**HILLS OF GOLD  
PRESERVATION INC 1800437**

**IPC SUBMISSION  
FEBRUARY 2024  
SSD-9679**

Hills of Gold Preservation Inc (HOGPI) members submit evidence to support presentations to the Independent Planning Commission (IPC) Hills of Gold Wind Farm Public Meetings on February 1-2, 2024.

**Figure B.1.1.2.** Transmission Line (Option 1) Photomontage PM01 (Representative of AD\_74)

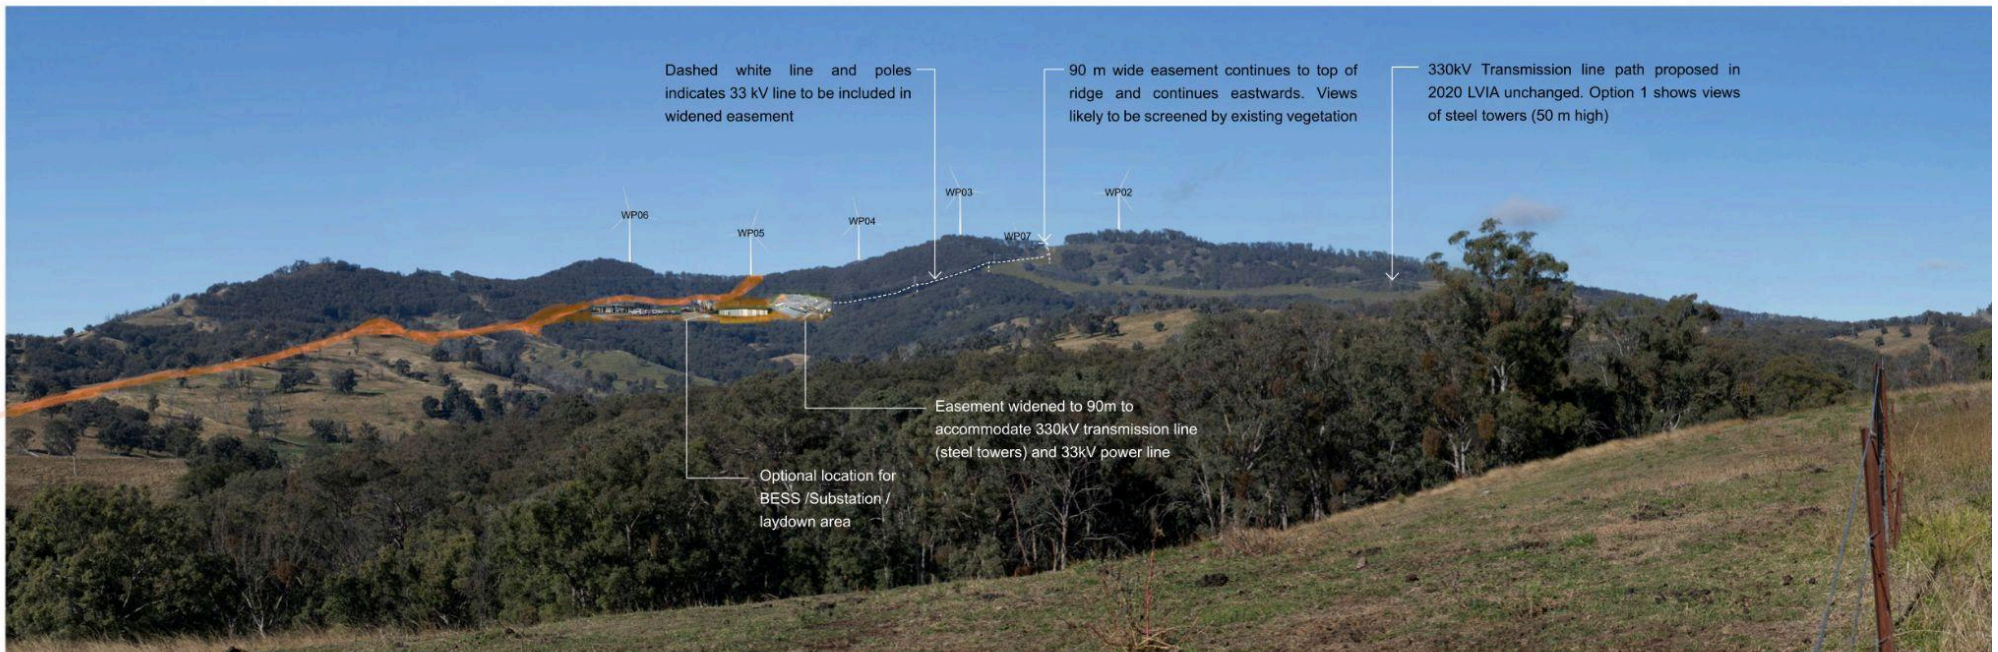
**NO PHOTOMONTAGE** depicting this OSOM road traversing steep terrain from the Crawney Road (access Option B) to the development corridor on the ridge.

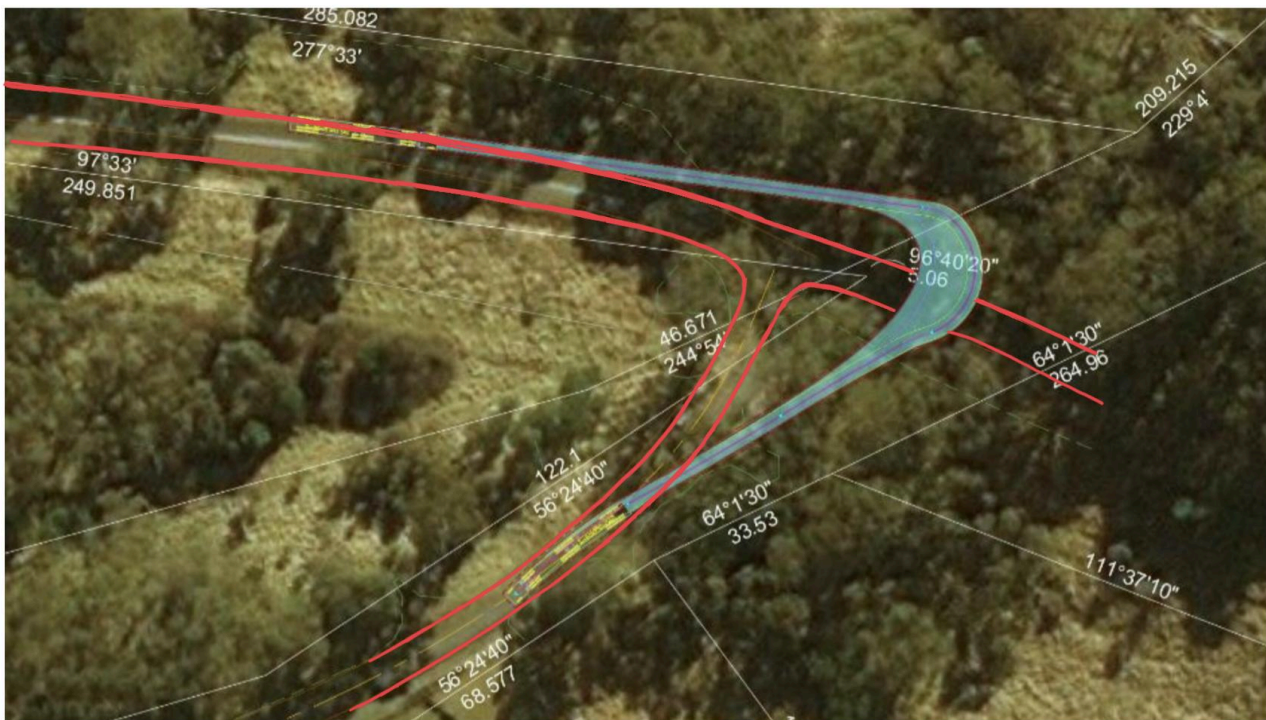
The below diagram depicts a B-Double truck movement around Barry Rd/Morrisons Gap Rd intersection. The transport is proposed to turn from the correct site to the correct side of a NON EXISTENT road. **The diagram states that no modifications are required.** The footprint of the B-Double turn depicted does not follow the road in place. This might be an attempt to solve the encroachment on private property. Is this a proposal to construct a new intersection? If so, when was the council and community notified?

**ROAD MODIFICATIONS:** No modifications required. ??

**HOGPI recommendation:** prohibit the use of Morrisons Gap road by heavy vehicles and heavy vehicles requiring escort.

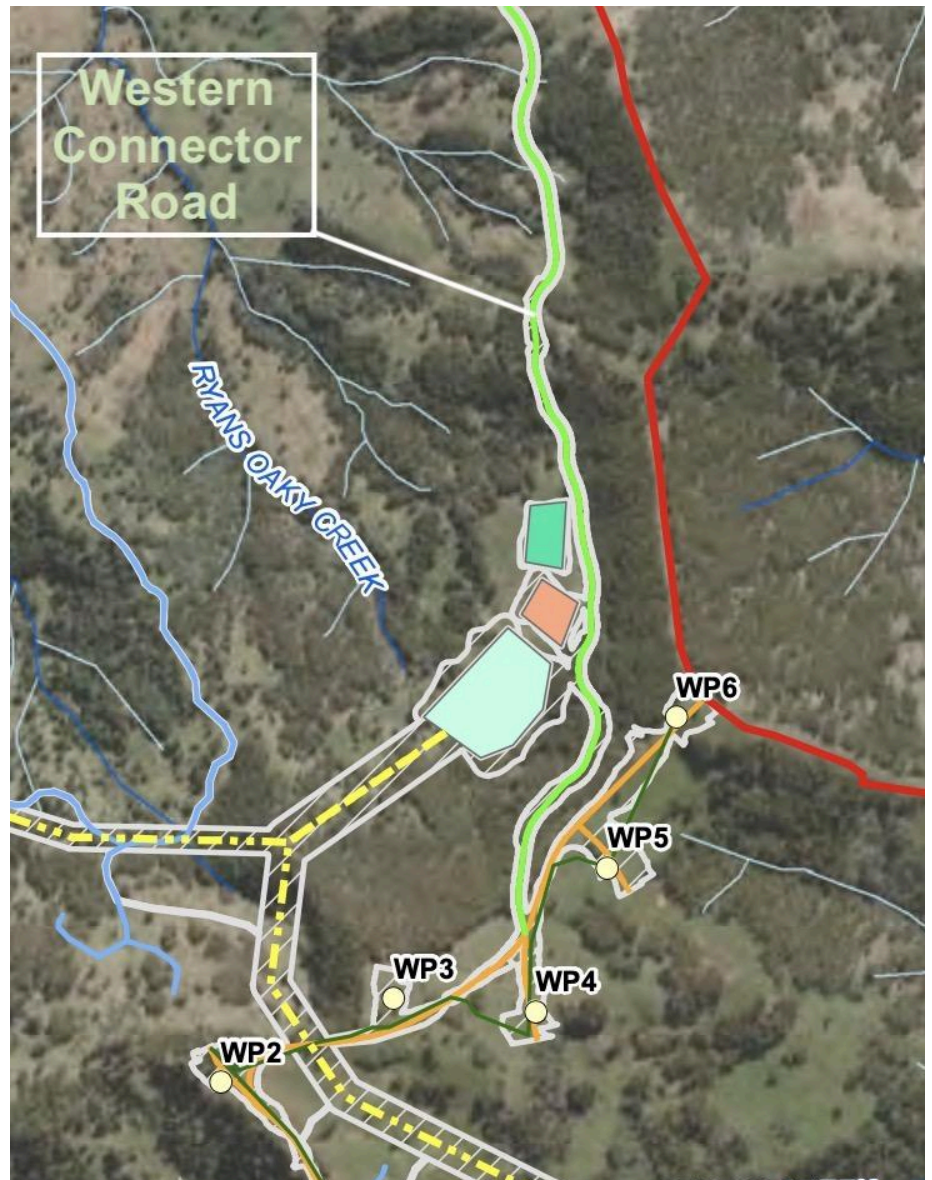
The southern end of the Western Connector road (green) climbs above the shelf housing the substation complex and proceeds diagonally across a slope greater than 40%. The narrow footprint of this section of the OSOM access road, which was excluded from the constructibility advice, is completely unrealistic.

Yellow dots - identified waterway crossings.

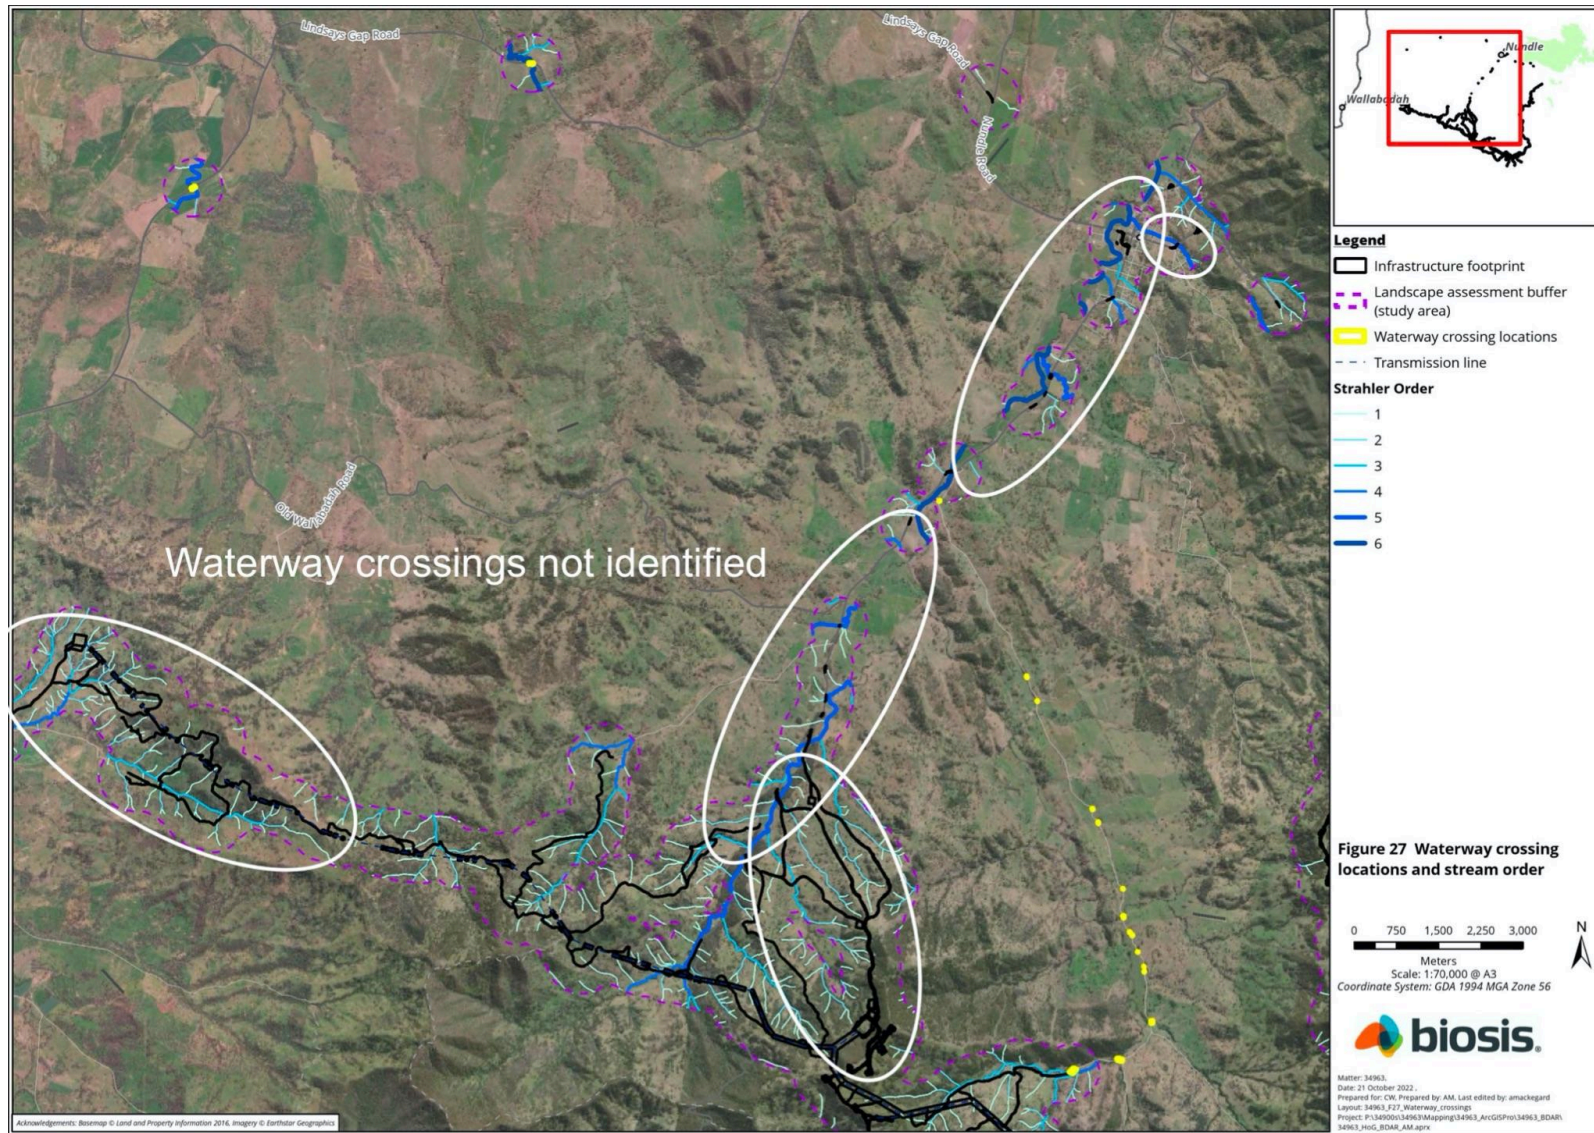
Chapter 8.4 did identify Wombramurra creek crossing.

Biosis relied on desktop studies rather than the field work and didn't identify a requirement for a **new bridge** at Wombramurra Creek.

## 2) Optional substation location on the Governor's shelf.

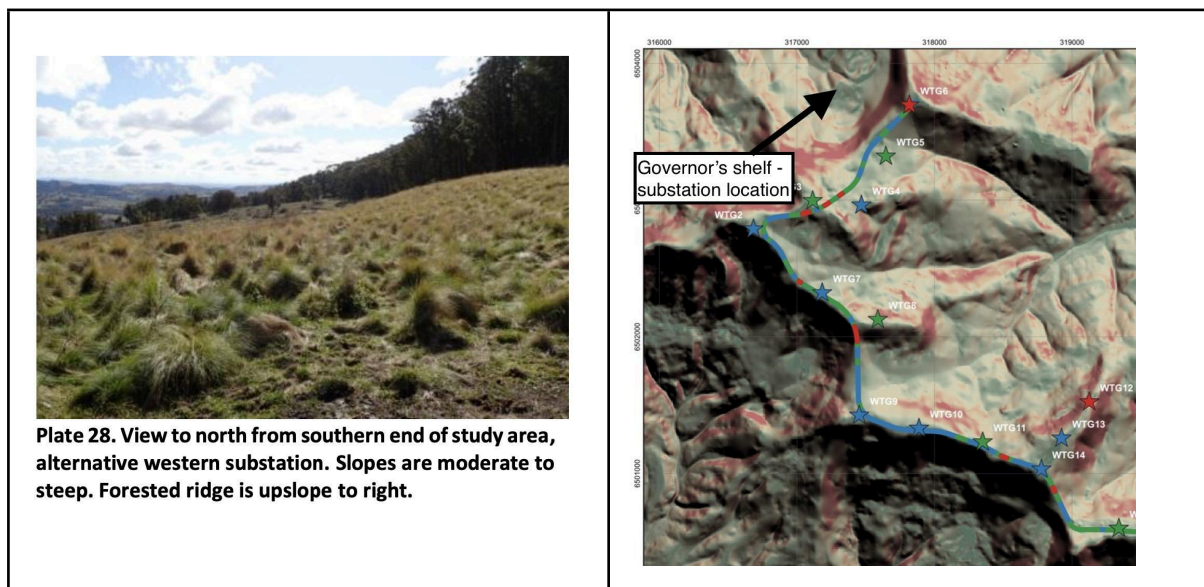
The optional location of the substation complex also escaped the scrutiny of the Advice being **excluded** from the document itself or any maps provided.

**The Transverse Track (TT) - connecting two halves of the wind farm:**

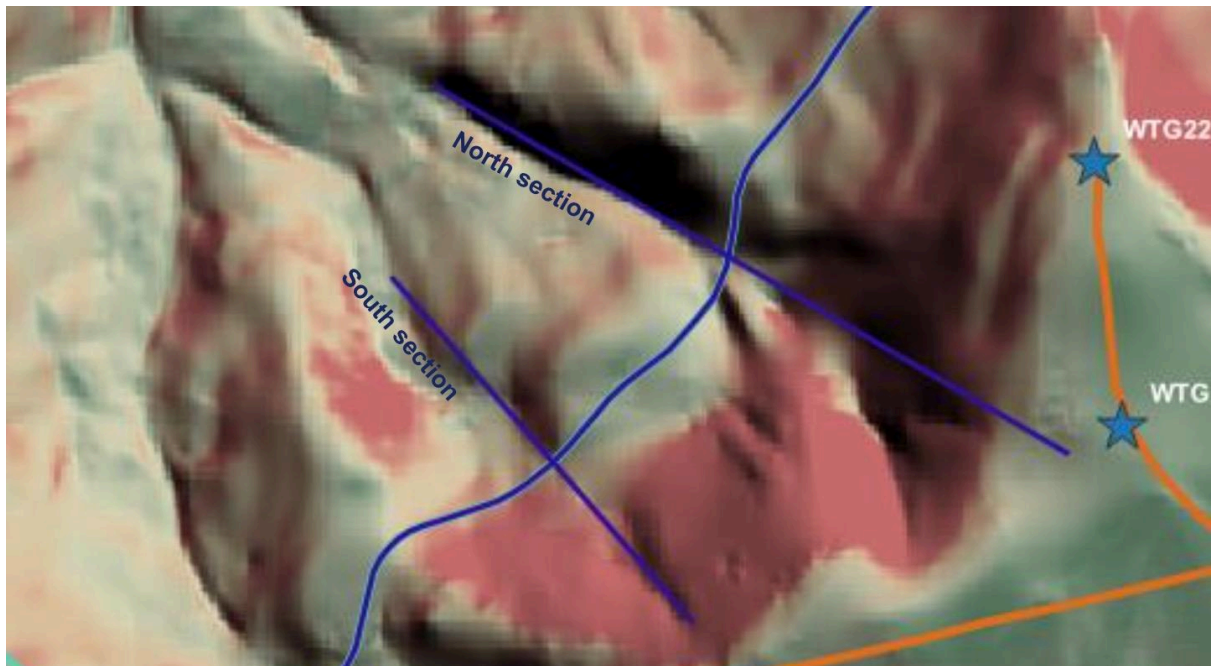
HOGPI continues to be concerned about the constructability of the 6.7km long Transverse Track, particularly the section across two deep gullies, one of which is Talbots creek.
